DELRAY BEACH COMMUNITY REDEVELOPMENT AGENCY (CRA)
INVITATION TO BID (ITB) CRA NO. 2025-03
EXTERIOR AND INTERIOR REPAIRS TO THE CRA-OWNED BUILDING
LOCATED AT 313 NE 3rd STREET – ARTS WAREHOUSE

DIVISION 1 / GENERAL CONDITIONS	COST	COMMENTS
General Conditions		
Permits		
Waste Removal		
Final Cleaning		
Other		
DIVISION 2 / EXISTING CONDITIONS	COST	COMMENTS
Demolition		
Testing		
Other		
DIVISION 3 / CONCRETE	COST	COMMENTS
Concrete slab repair		
Other		
DIVISION 6 / WOODS AND PLASTICS	COST	COMMENTS
Rough Carpentry		
Other		
DIVISION 7 / THERMAL MOISTURE/ROOFING	COST	COMMENTS
Roof Overlay and New Parapet Membrane System(s)		
Miscellaneous Sheet Metal Flashings, Trim, Gutters & Downspouts		
Rigid Insulation Replacement if Damage is found - Allowance (700 square feet) Allowance		
Unit cost of insulation beyond 700 SF	\$ per SF	
DIVISION 9 / PAINTING	COST	COMMENTS
Pressure Washing		
Surface Preparation		
Painting		
Stucco Repair - Allowance (200 square feet)		
Unit cost of Stucco Repair beyond 200 SF.	\$ per SF

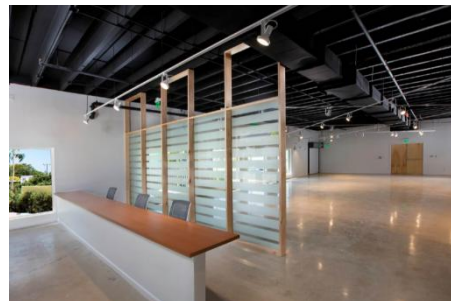
See below picture of the referenced desk/pony wall.

3
A3.1 PARAPET DETAIL

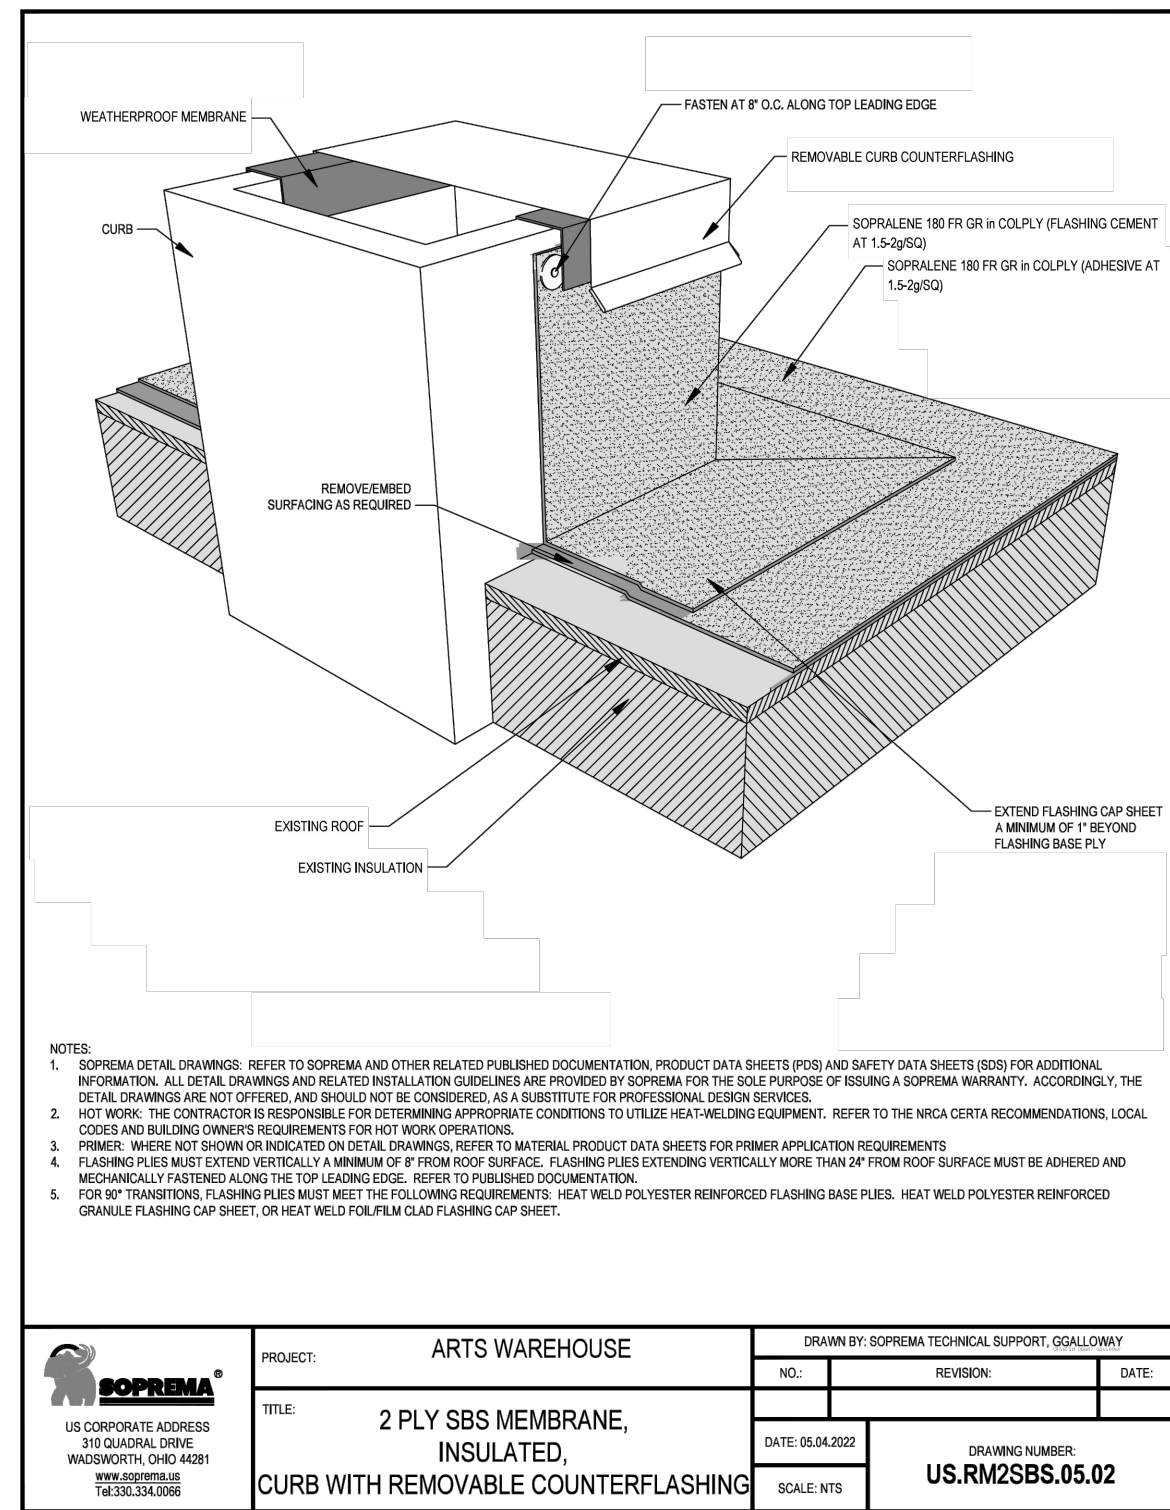
15. **Parapet detail 3 on Sheet 3.1 states replace would blocking as needed. Do you have the size of the blocking (detail is not to scale)? To bid accurately should we provide a unit price?**

All blocking shall be 2x P.T. material as shown in the detail the exact width shall be determined by the Contractor in the field to match the existing wall thickness (2x8 would most likely be required). Contractor to confirm final dimension once exposed after demolition.
